Errata Sheet

Product Family: Datalogic Safety Light Curtains
Manual / Revision: SG4 Base Instruction Manual / 06/2015, Rev. A
 SG4-B Series Quick Guide / 830000203 (Rev. C)

Date: May 30, 2018

Additional Wiring Information

Receiver M12 8-pole male connector

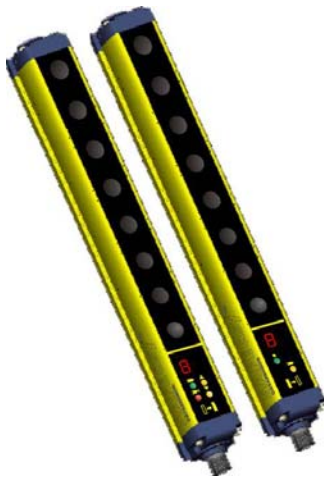
AutomationDirect sells M12 8-pole cables with two different color patterns (7000-170x1-292xxxx and 7000-170x1-295xxxx). We recommend the “292” series on our website, which matches the Datalogic cables color code. However, to help avoid confusion, please refer to the table below comparing the color codes.

The “295” series AutomationDirect cables can also be used but make sure to follow the color codes shown here.

We recommend the “292” series AutomationDirect M12 cables because the wire color codes match the Datalogic cables color codes.

Assignment	Function	Pins on Sender	Datalogic Cable Color Codes	Recommended Cable Color Codes	Additional Cable Color Codes
		M12		7000-170x1-292xxxx	7000-170x1-295xxxx
Reset / Restart	Automatic / Manual reset / Restart	1	White	White	Brown
Supply Voltage	+24VDC	2	Brown	Brown	White
EDM	EDM Activation	3	Green	Green	Blue
EDM	EDM	4	Yellow	Yellow	Black
Output	OSSD1 (Output Single Switching Device)	5	Grey	Grey	Grey
Output	OSSD2 (Output Single Switching Device)	6	Pink	Pink	Pink
0V	0V	7	Blue	Blue	Violet
Reset Selection	Select Automatic / Manual reset	8	Red	Red	Orange

CONNECTIONS

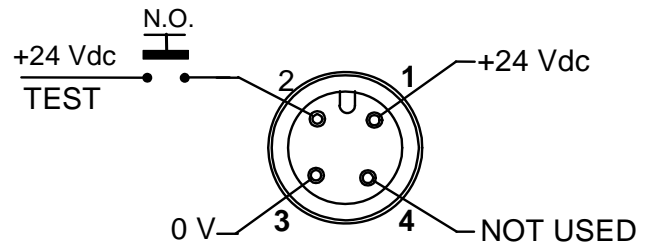
Please see the Errata Sheet on the first page of this manual for additional wiring information.
